**NOTICE OF MEETING**
**CITY COUNCIL OF THE CITY OF GALVESTON**
**THURSDAY - FEBRUARY 27, 2020 - 1:15 P.M.**
**COUNCIL CHAMBERS - CITY HALL**
**823 ROSENBERG, GALVESTON, TEXAS**
**TELEPHONE: (409) 797-3510**

8.A. Consider For Approval An Ordinance Of The City Of Galveston, Texas, Creating A Planned Unit Development (PUD) Overlay Zoning District In A Commercial, (C) Base Zoning District With A Height And Density Development Zone, Zone-6 (C-HDDZ-6) Overlay Zoning District To Allow A Ten-Story Apartment Development To Be Constructed On The Property Commonly Known As 12212 San Luis Pass Road And Which Is Legally Described As The West 311.7 Feet Of Lot 1, Resort Subdivision, In The City And County Of Galveston, Texas; Planning Case Number 20P-002; Making

**REQUEST:**
Planned Unit Development (PUD)

**EXHIBITS:**
A – Zoning Map
B – Narrative/ PUD Plan
C – Site Plan/PUD Plan

SD1.0
Site Plan
01/024/2020

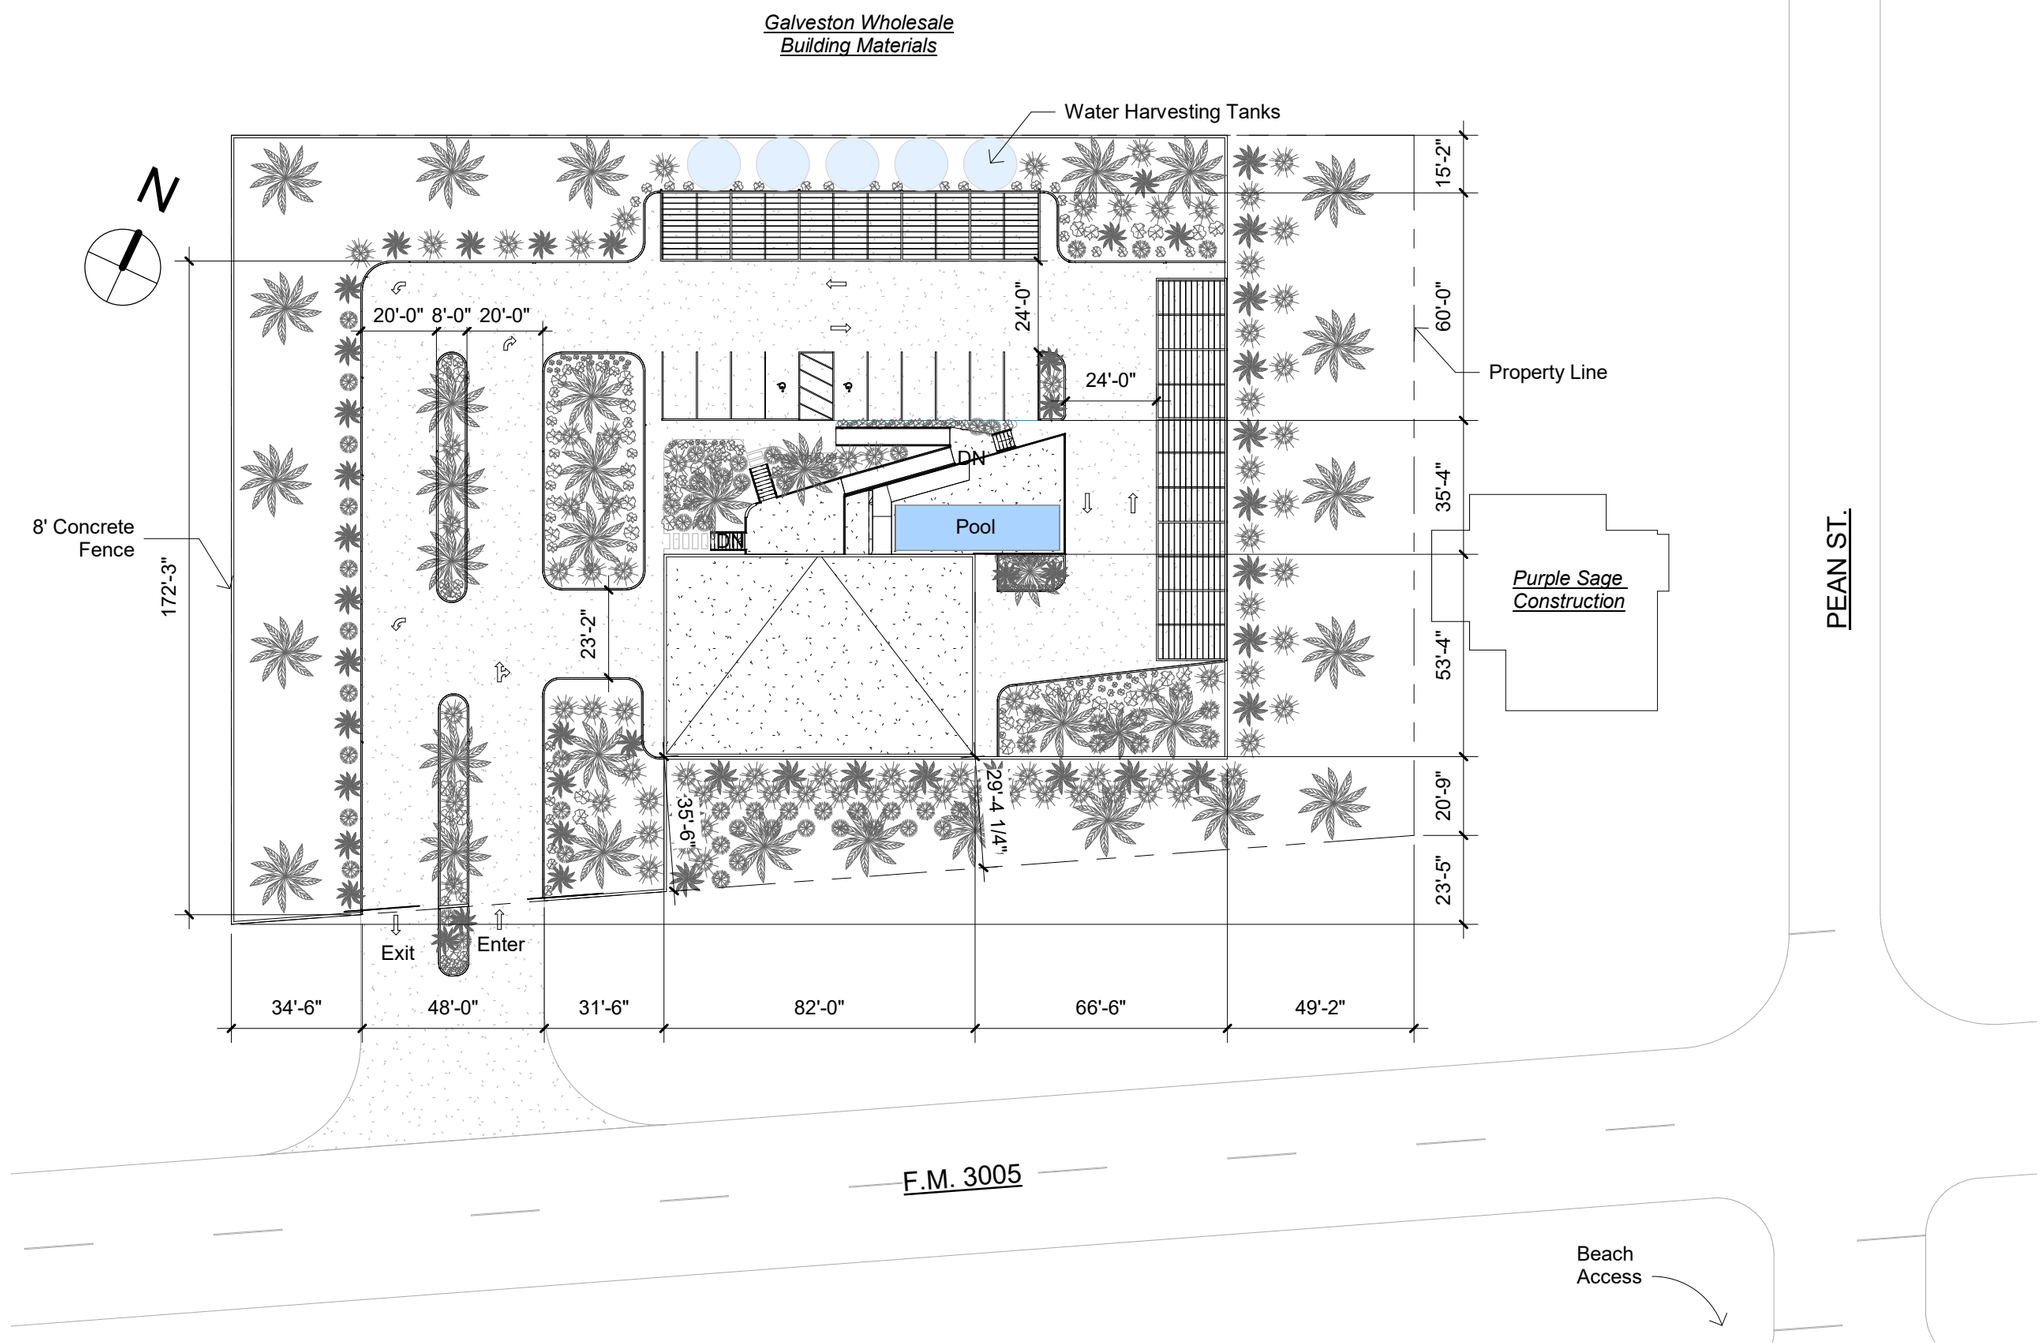
| **Screening and Landscape** | The applicant has proposed native and adapted landscape species, and drought tolerant turf grass. The project will use water harvesting to provide all of the landscape irrigation. *Please reference SD 1.0* and page 2, Exhibit: C – Narrative. |

west end. This development would allow a wide variety and larger inventory of housing on the west end. Staff finds, that a clear beach access plan that includes signage, sidewalks and a clear path to and from the beach access point should be developed and submitted by the applicant. This will ensure safety and keep pedestrians from trespassing across private property while accessing the beach.

g. The applicant shall provide a clear beach access plan that includes signage, sidewalks and a clear path to and from the beach access point across San Luis Pass Road;

SD1.1
Parking Level
01/024/2020

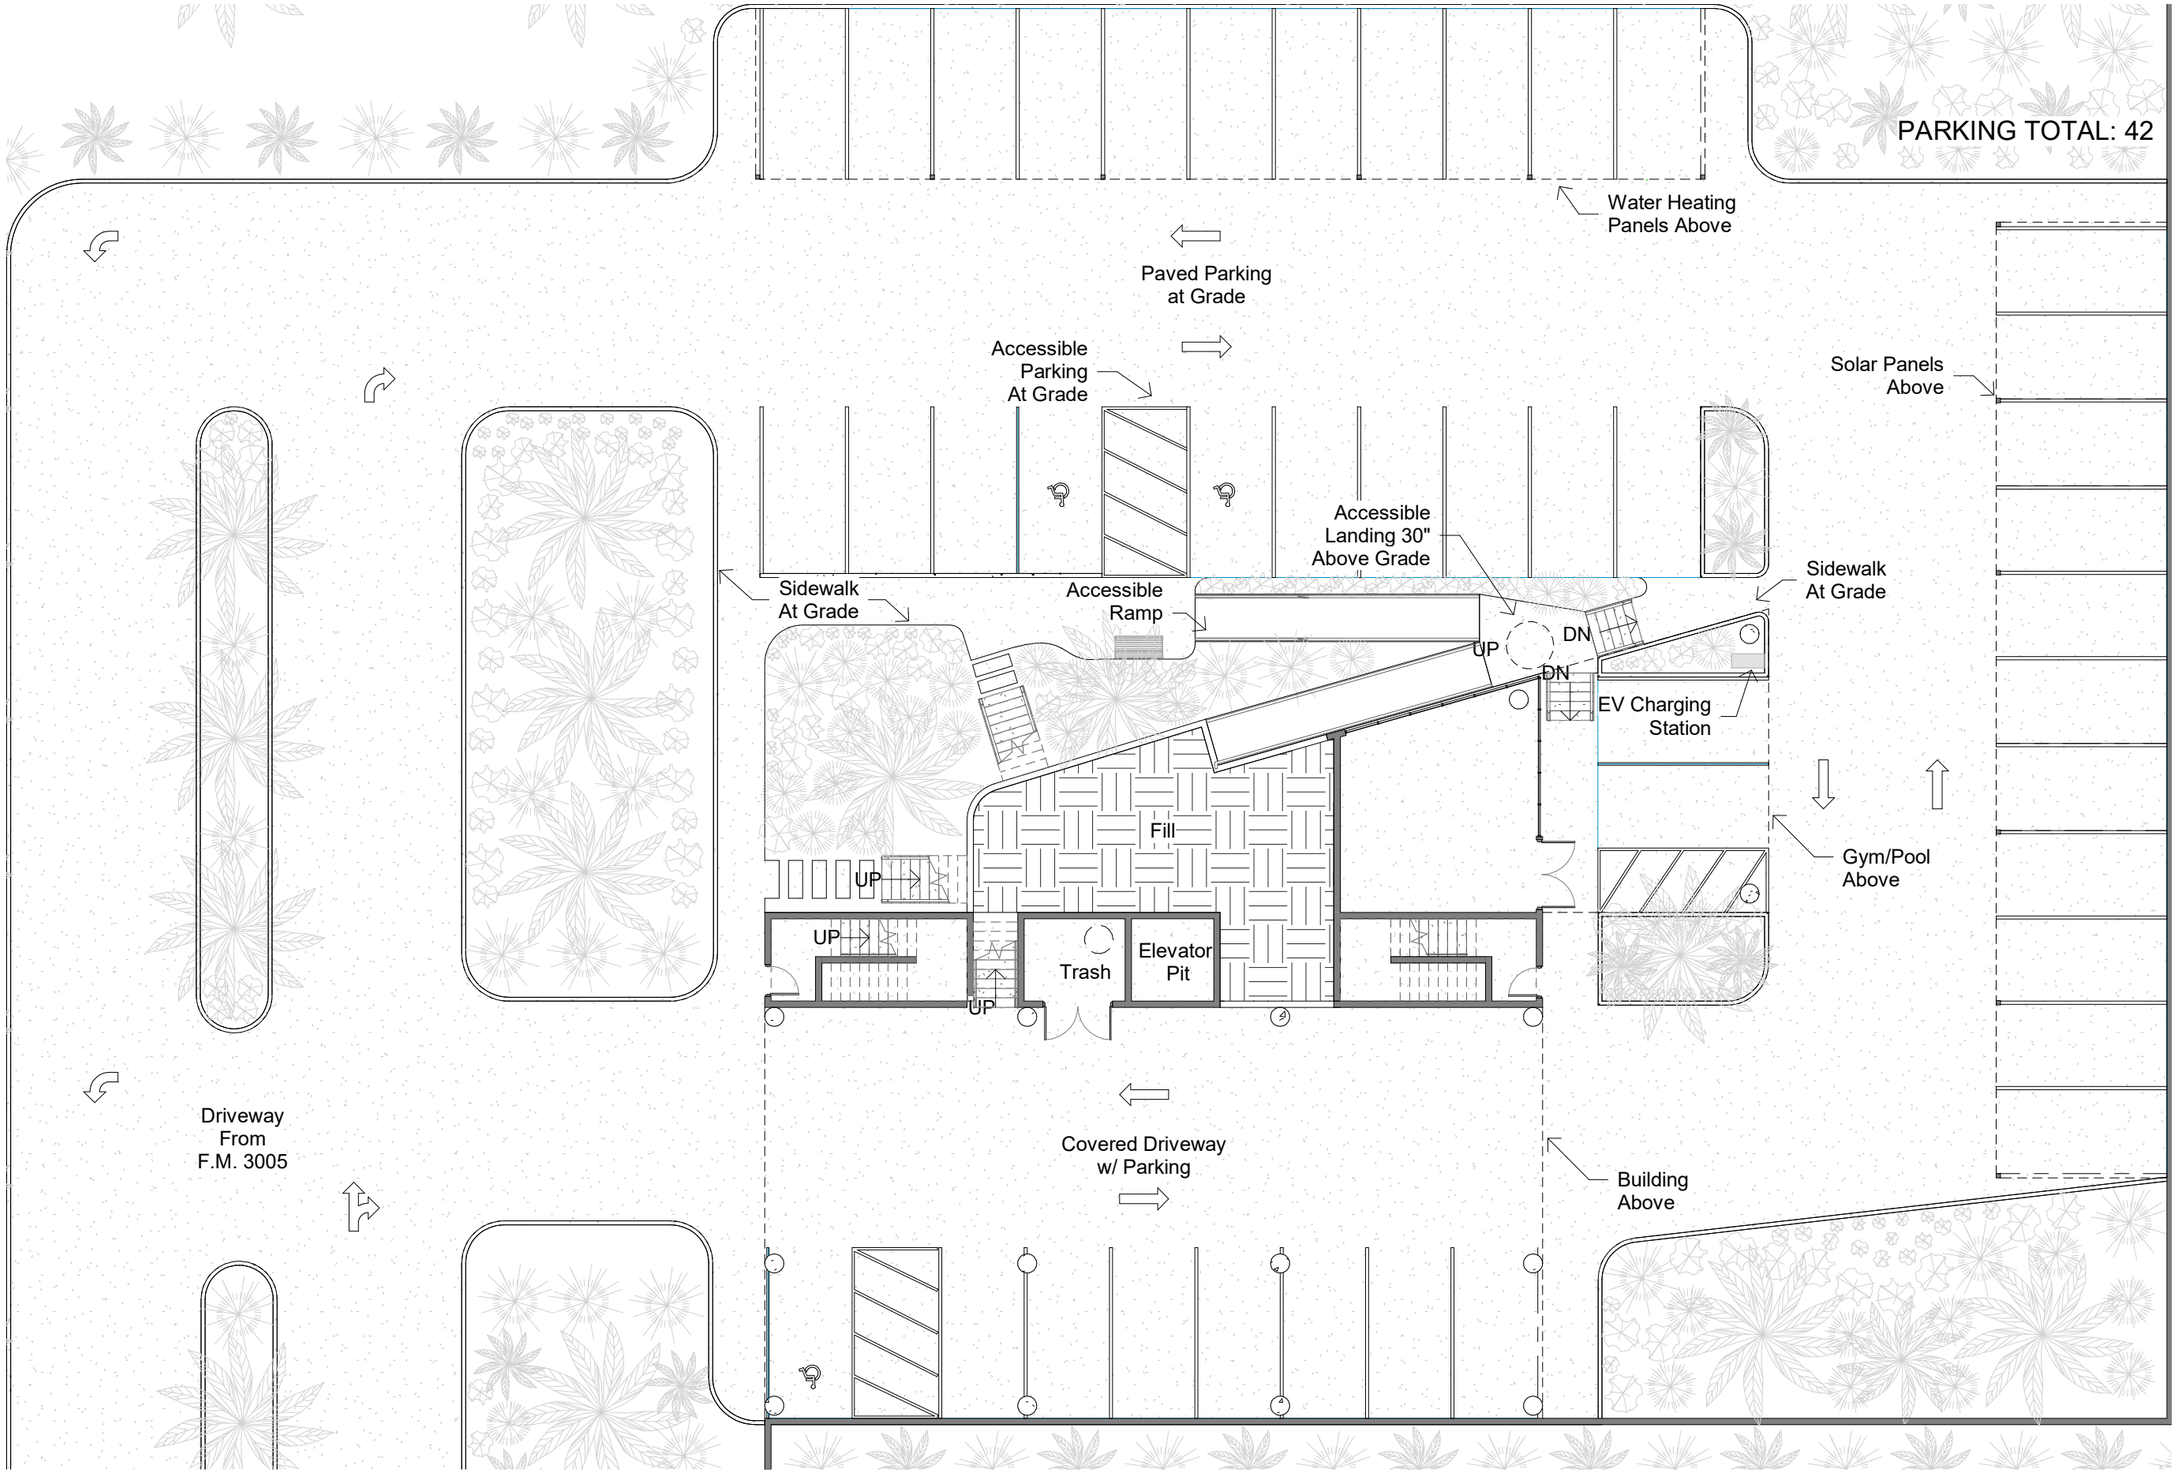
| **Streets and Circulation** | The existing curb cut on San Luis Pass Road will be utilized as the entrance and exit for the development. The plan includes a clear onsite traffic circulation plan. *Please reference SD 1.1 and page 2, Exhibit: C - Narrative.* |
